STAFF REPORT
KETCHUM PLANNING AND ZONING COMMISSION
REGULAR MEETING OF OCTOBER 14, 2019

PROJECT: Onyx at Leadville Residences Condominium Subdivision Preliminary Plat

FILE NUMBER: P19-093

Exhibit C:
City Engineer
Review Comments

Exhibit B:
Condominium Subdivision
Preliminary Plat
dated August 2019

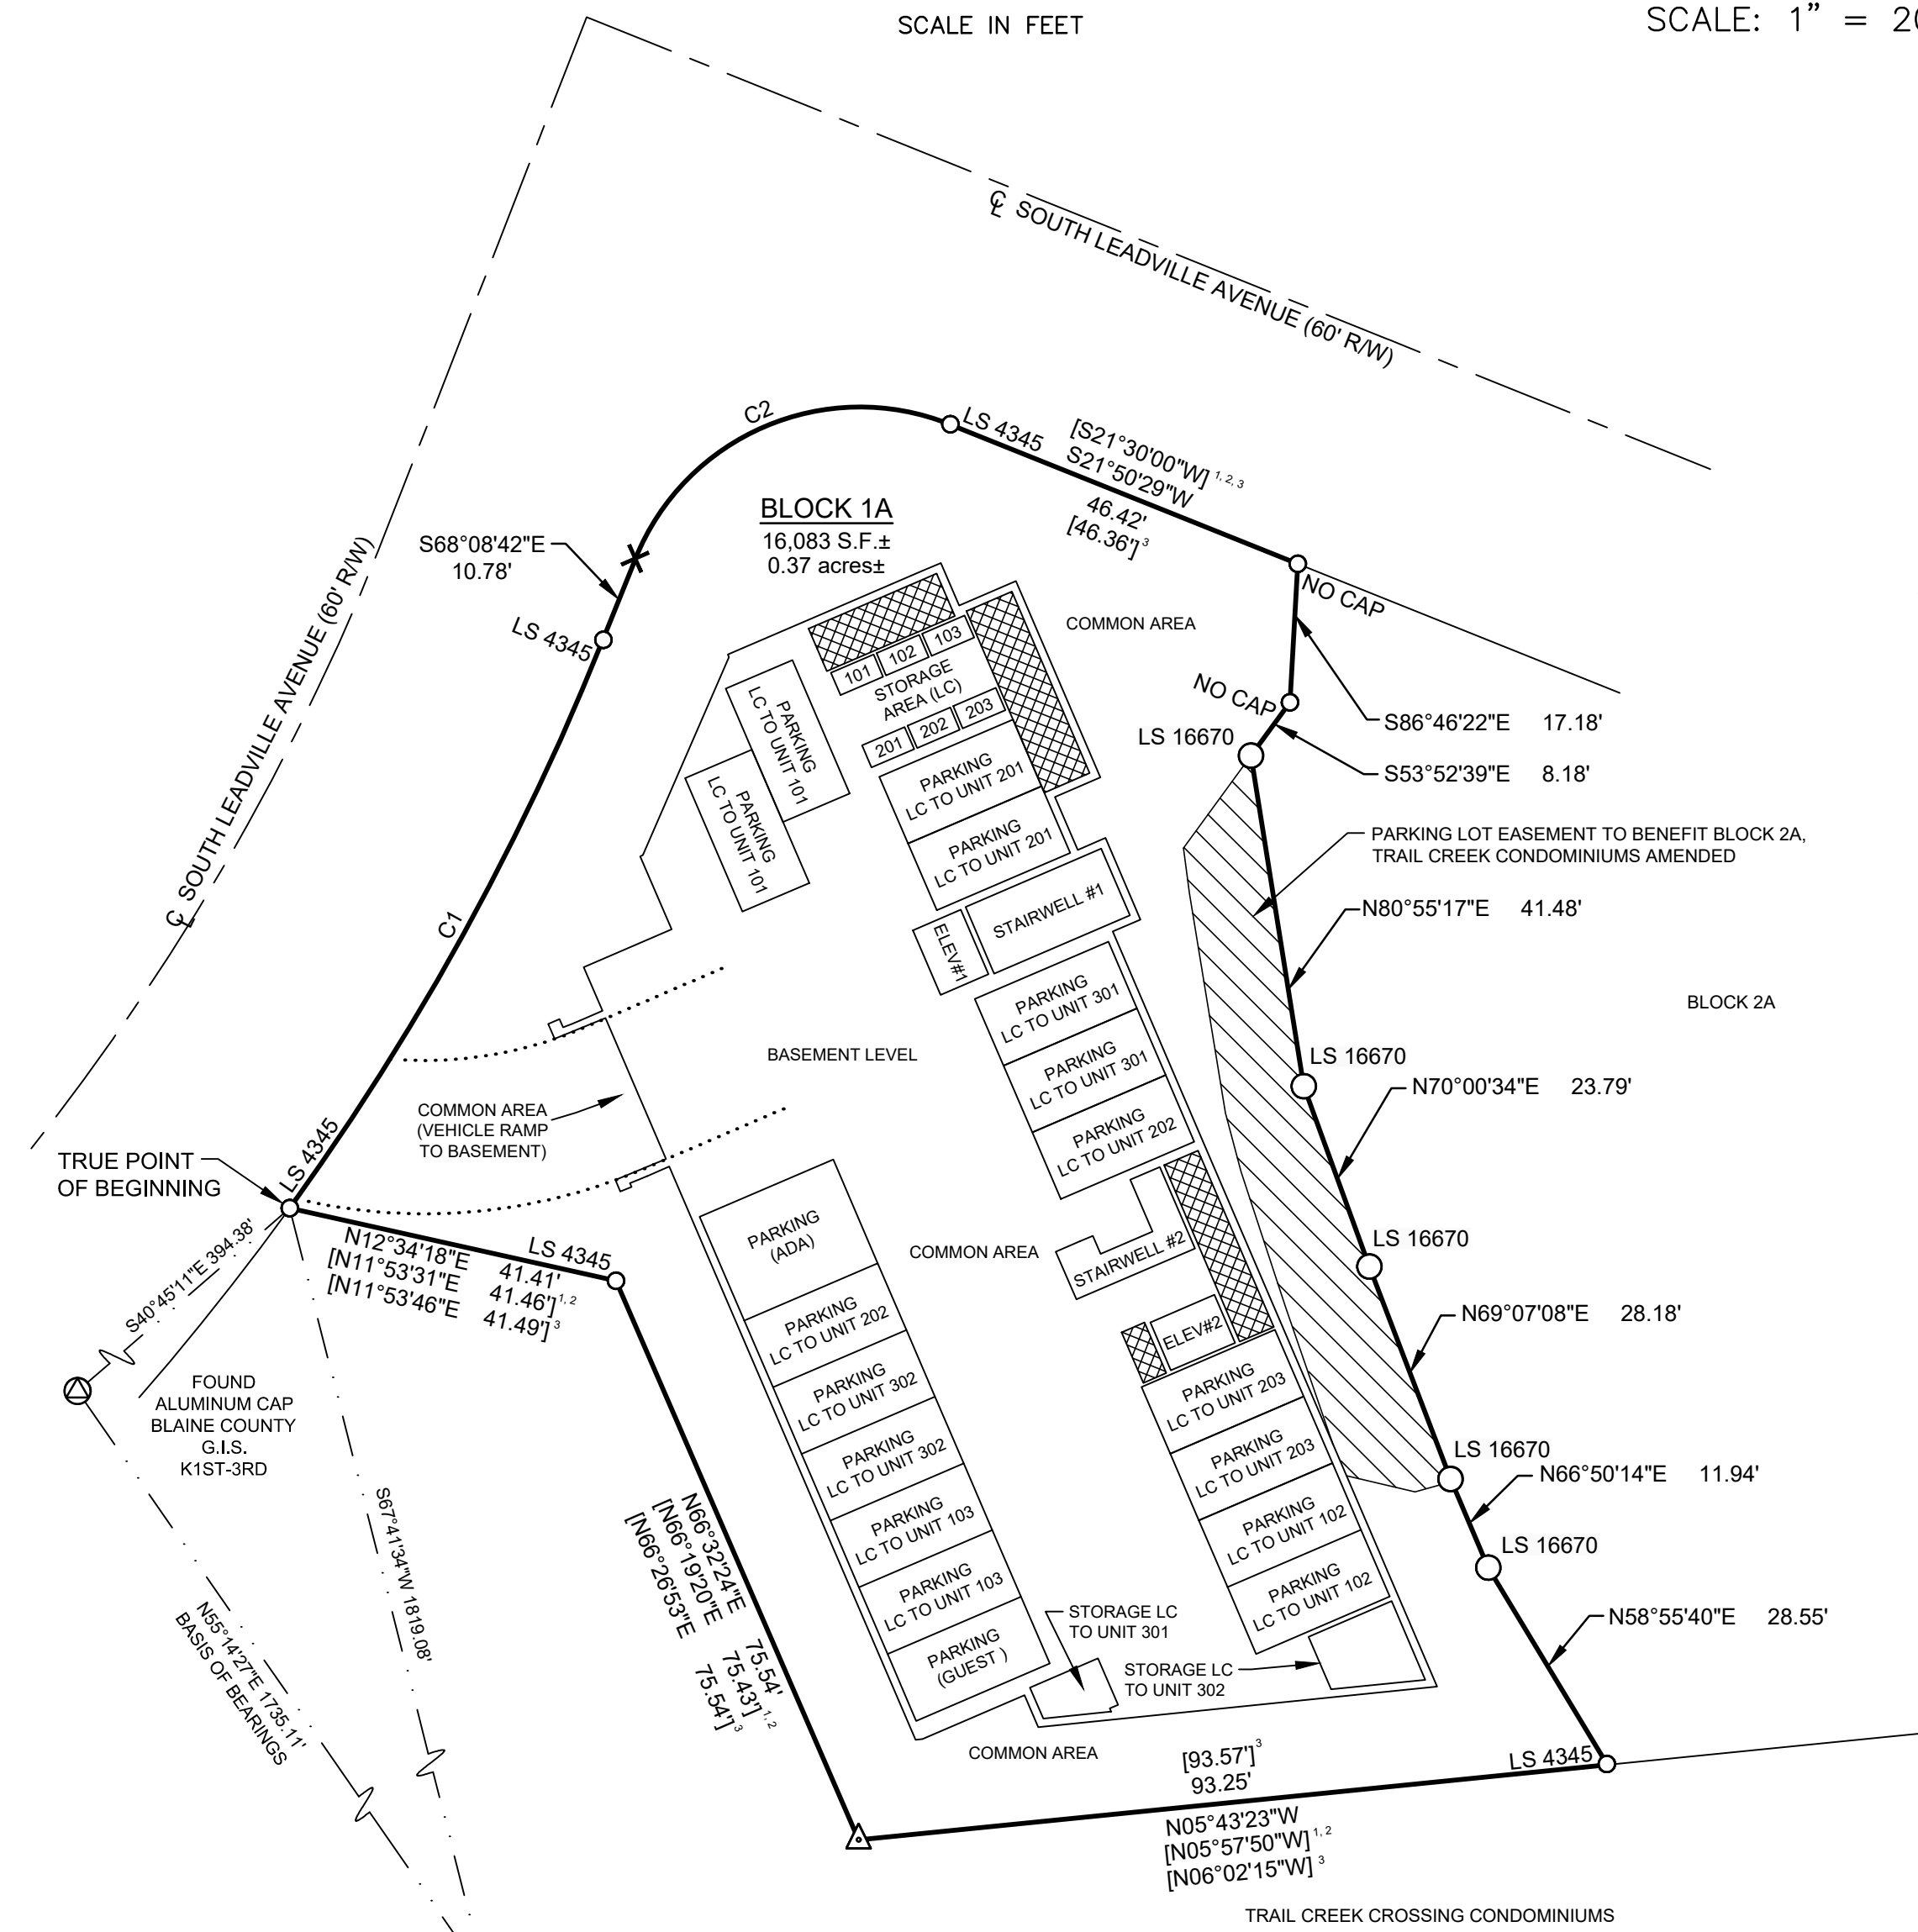
1. Pursuant to KMC §16.04.030.I9, the zoning designation for the subject property, Tourist, shall be added to the Preliminary Plat prior to forwarding the Plat to City Council for review.

3. As noted in the City Engineer review comments dated October 9, 2019, the applicant shall include the following items on the Final Plat: (a) the 5 ft public utility easement as required pursuant to KMC §16.04.030.I9, (b) certifications, (c) certificate of owner, (d) surveyor approval, and (e) agency approvals.

NO.	ITEM	PROVIDED	COMMENT
1	Subdivision Name tied to at least 2 corners	X	
2	Surveyor Stamp/certification	X	
3	Date	X	
4	Sheet Title and Preamble	X	
5	Basis of Bearing	X	
6	North Arrow	X	
7	Scale	X	
8	Plat Closure	X	
9	Total Area	X	
10	Monuments	X	
11	Land Corners	X	
13	Street Names & Width & Centerlines	X	
14	Easements – Utilities		Show 5' easement on Final Plat
15	Lot & Block Numbers	X	
16	Lot Dimensions	X	
17	Curve & Line Tables	X	
18	Certifications		Provide on final plat
19	Certificate of Owner		Provide on final plat
20	Surveyor Approval		Provide on final plat
21	Sanitary Restriction/Health Certificate	X	
22	Agency Approvals:		Provide on final plat
23	Public Dedication:	NA	
24	Common Areas:	X	
25	Legend	X	
26	Notes	X	
27	Condominium CC&R or CC&R reference		Provide copy of CC&R's to city
28	18" x 24" Mylar		Provide on final plat
29	Garages shown	X
